ADDENDUM #2

ISSUED SEPTEMBER 17, 2020 FOR BIDDERS OF

**MARLOW CONVENIENCE CENTER
RGCA PROJECT NO. 19701
BID NO. 2103**

THIS 36" DIAMETER FIRST DEFENSE HIGH CAPACITY GENERAL ARRANGEMENT

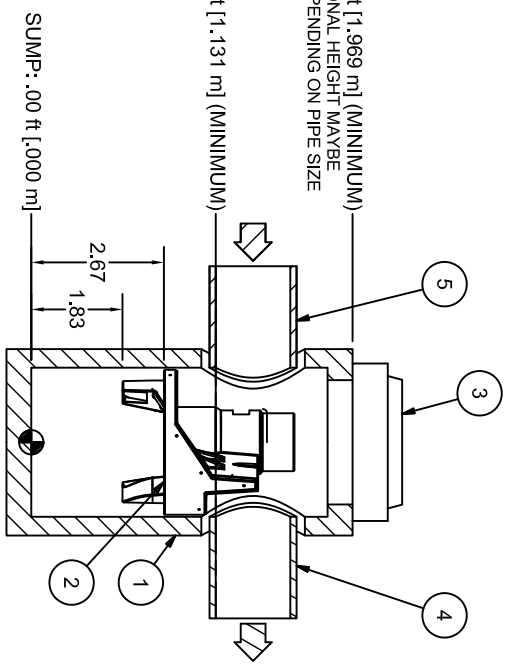
- 6) What other water quality unit can be used in lieu of the Aqua-Swirl AS-2? *Hydro International FDHC GA, or other equivalent structures may be used. A typical detail is attached.*

**6" SLOPING
DETACHED CONCRETE CURB**

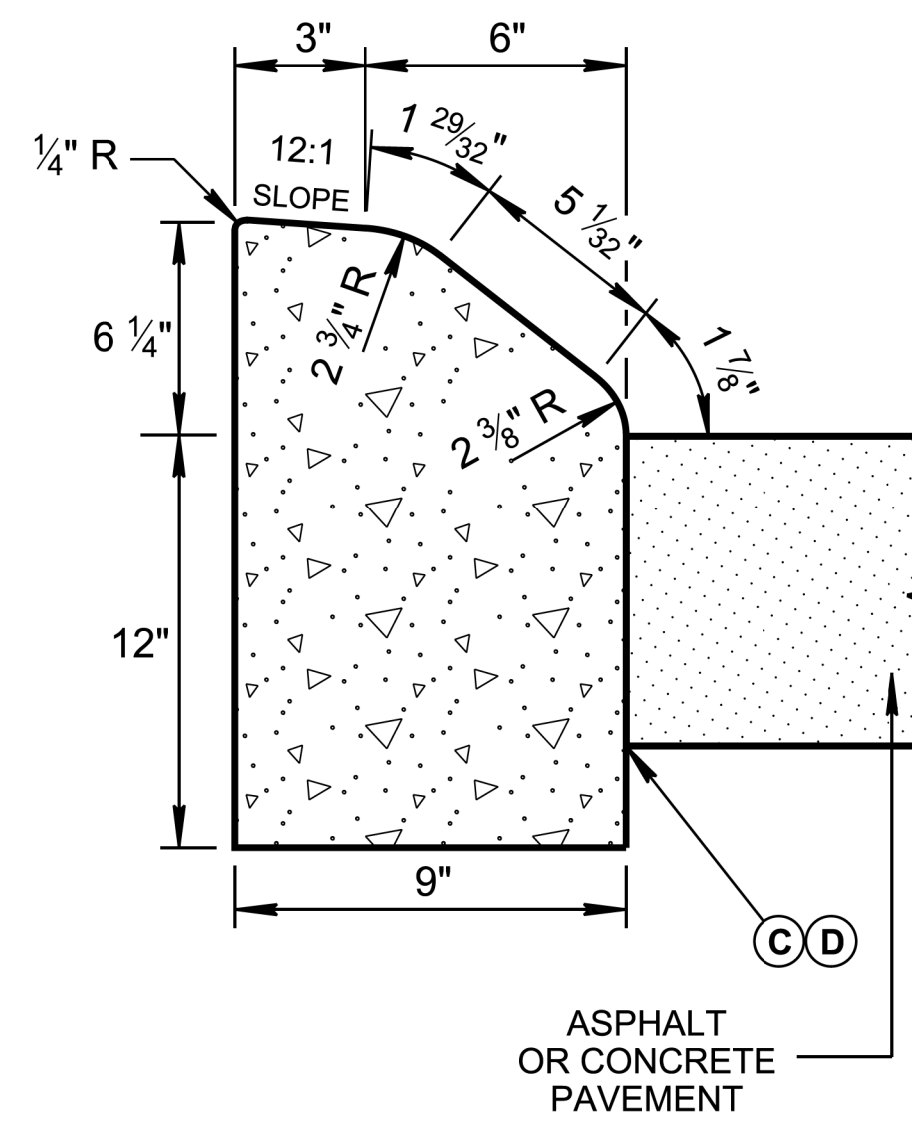
- 7) Please provide detail of the dowel on 15 foot centers required by the special provisions. *See detail on revised Plan Sheet 7*
- 8) The extruded curb detail doesn't quite match the overlay thickness. Does it need modified? *See revised curb detail.*

BULK COMPACTOR PAD DETAIL

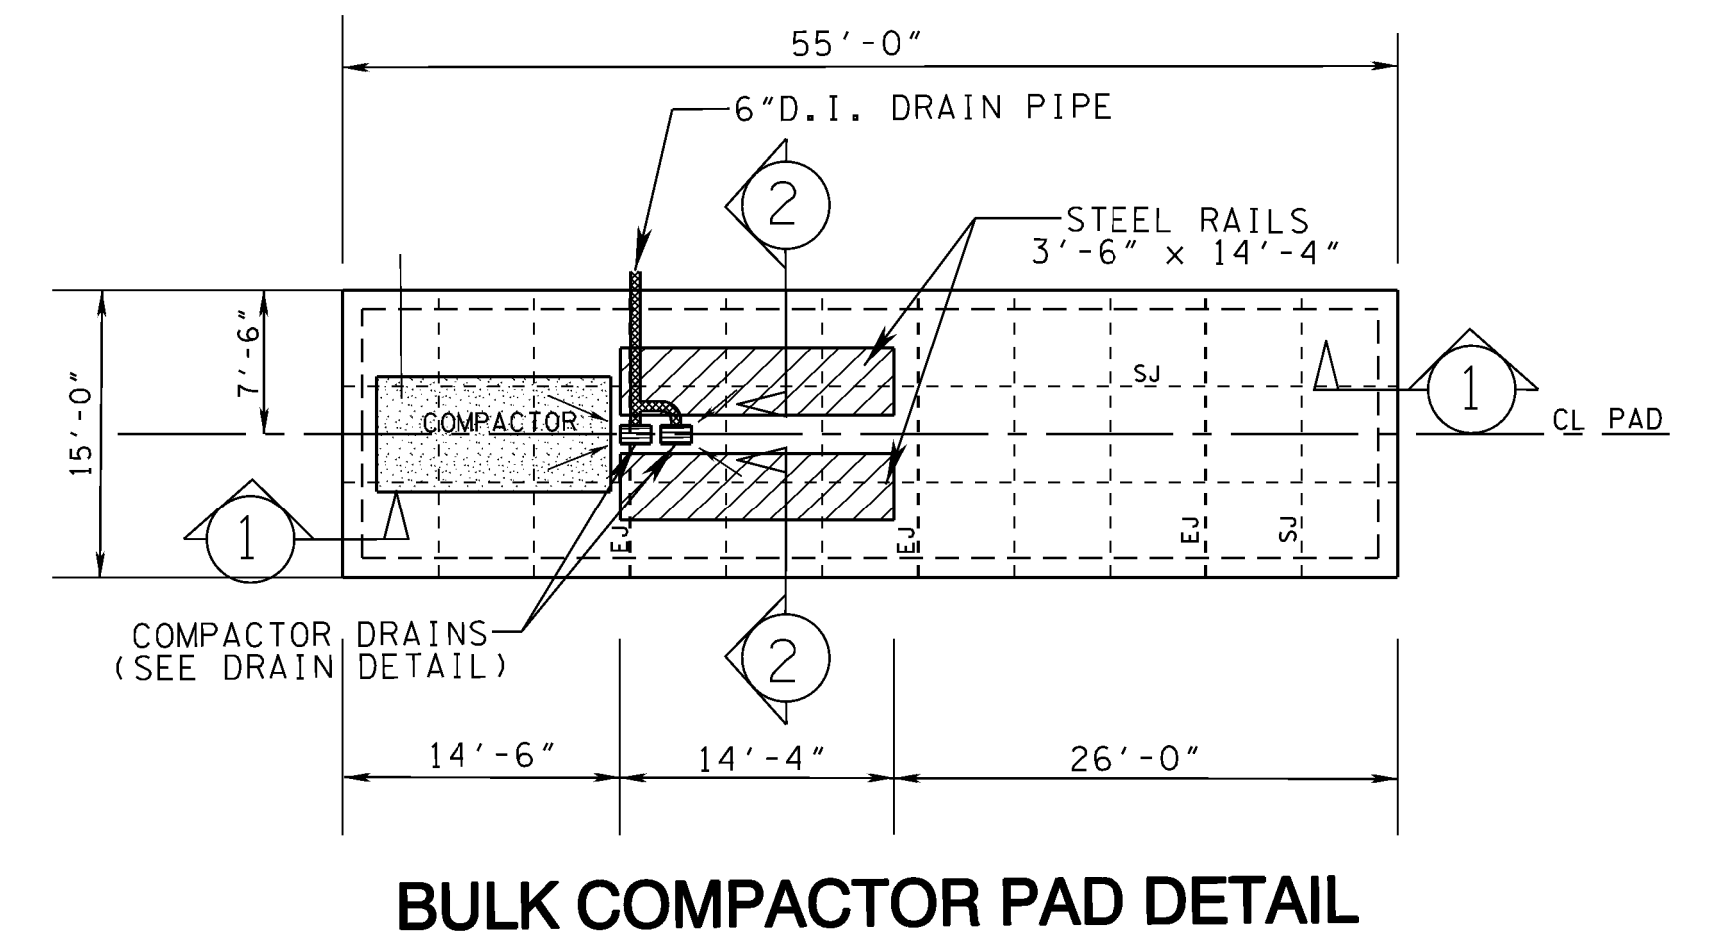
- 1) What is the compactor pad thickness? (Sections show 7 and 8 inches.) *The compactor pad thickness is to be 8 inches.*
- 2) Does sawcut item pay for all cutting? Ie., electrical trenches, cuts for storm and sewer install and compactor pads. *Yes, the sawcut is for removal of existing concrete for installation of storm, utilities, and compactor pads.*
